[Docket No. FAA-2020-0883; Project Identifier 2019-CE-034-AD; Amendment 39-21460; AD 2021-05-17]

Airworthiness Directives; Rockwell Collins, Inc. Flight Display System Application

ACTION: Final rule.

Figure 1 to paragraph (g)(1)(iii); placard location on bezel

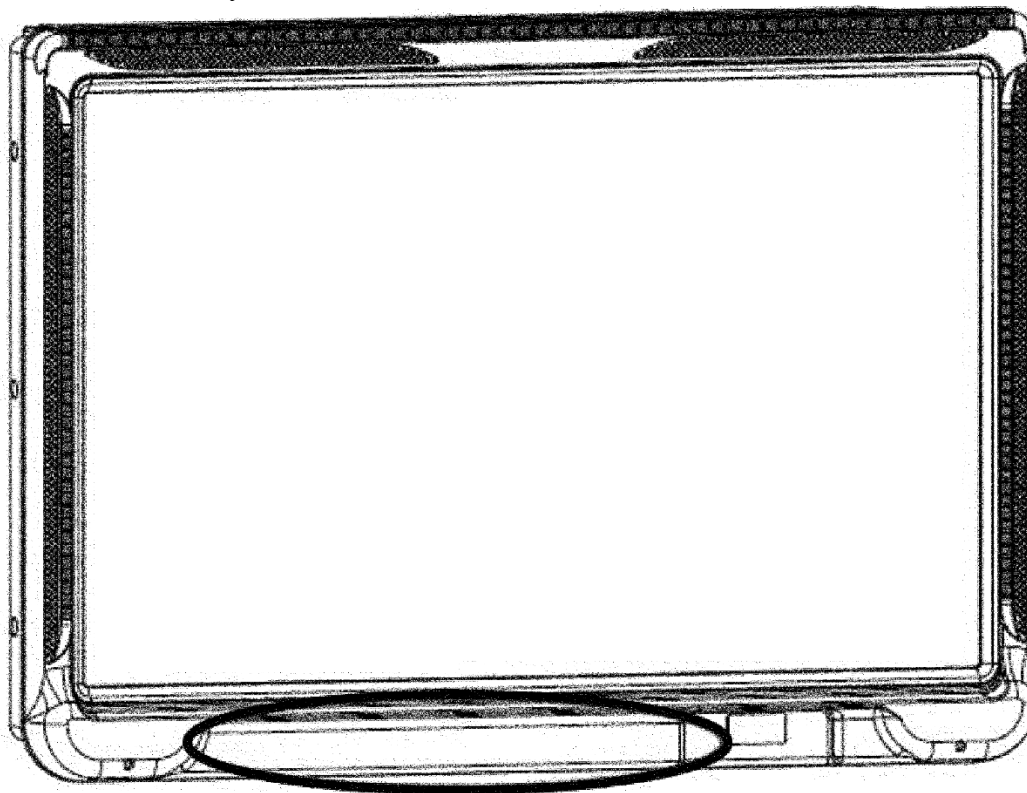
(iii) Install the placard on the bottom of each aircraft primary flight display bezel in the area depicted in figure 1 to paragraph (g)(1)(iii) of this AD.
